**CALIFORNIA REGIONAL WATER QUALITY CONTROL BOARD
SAN DIEGO REGION**

**PRELIMINARY
TECHNICAL ANALYSIS
SUPPORTING**

**SAN DIEGO UNIFIED SCHOOL DISTRICT
FOR
FAILURE TO COMPLY
WITH**

**ORDER NO. 99-08-DWQ
WASTE DISCHARGE REQUIREMENTS
FOR DISCHARGES OF STORMWATER RUNOFF
ASSOCIATED WITH CONSTRUCTION ACTIVITY
(WDID No. 9 37C329152)**

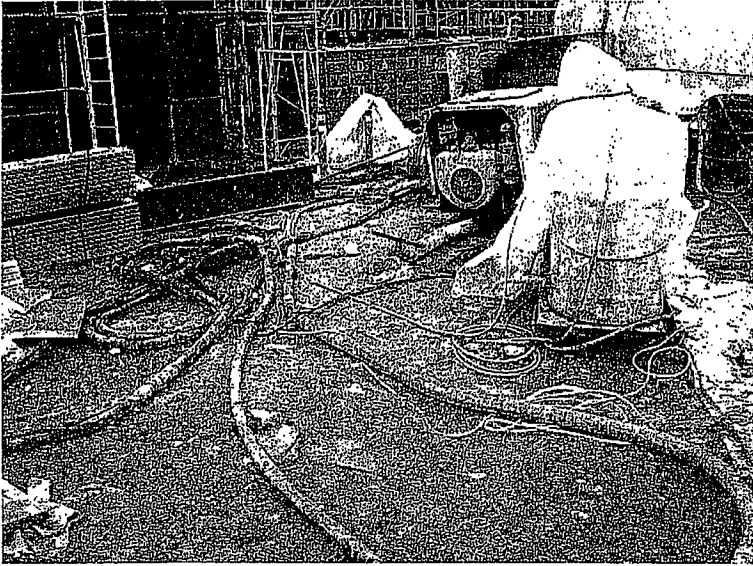
199. Material spills are on the ground with no containment to minimize contact with runoff.

204. Construction trash is not covered to minimize contact with storm water.

210. Soil stockpiles near Carroll Canyon Creek do not have cover or containment.

Photograph #11

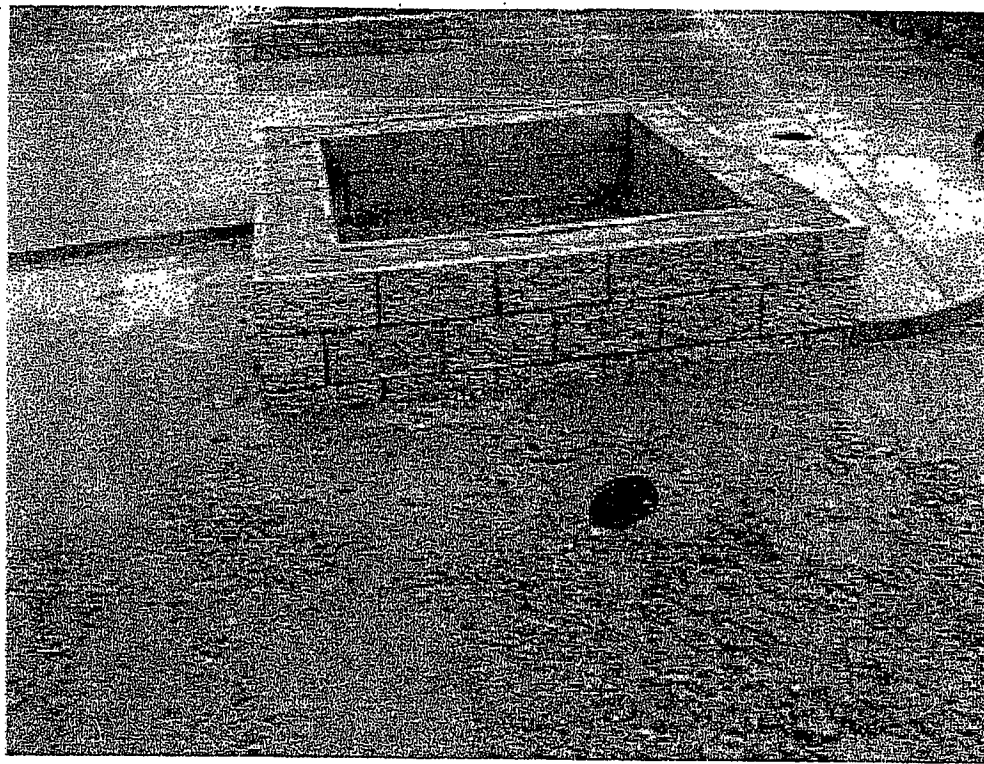
Comments:
Drain inlet near building in north central portion of site with no protection.

Photograph #13

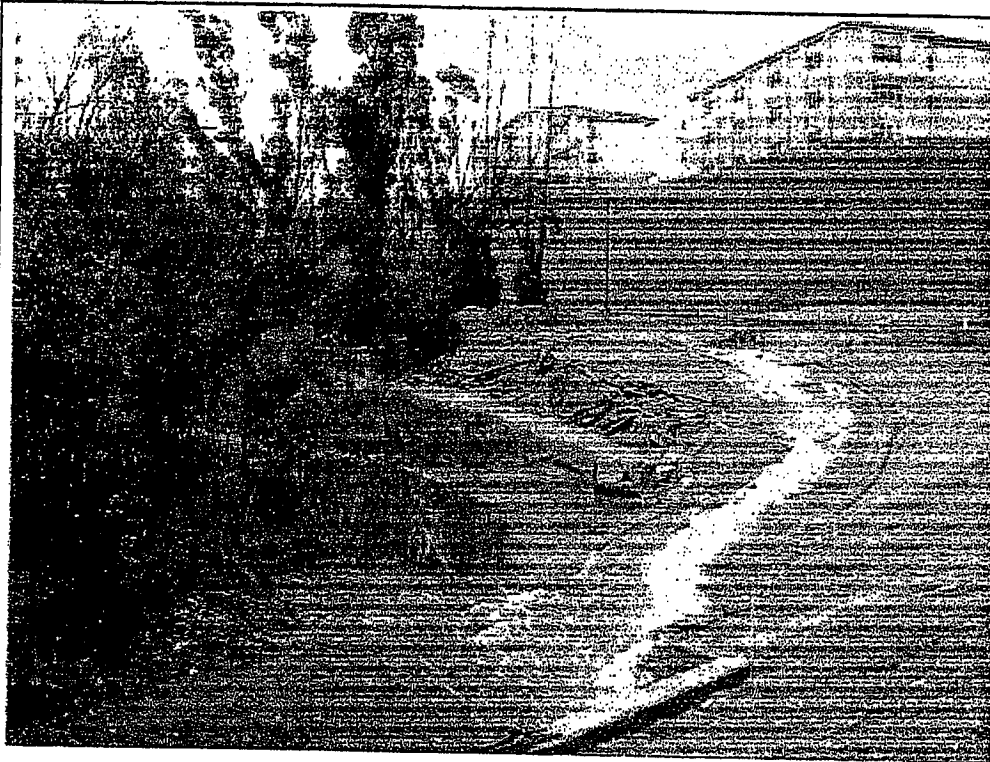
Comments:
Storm drain stub up located at grade and receiving runoff.
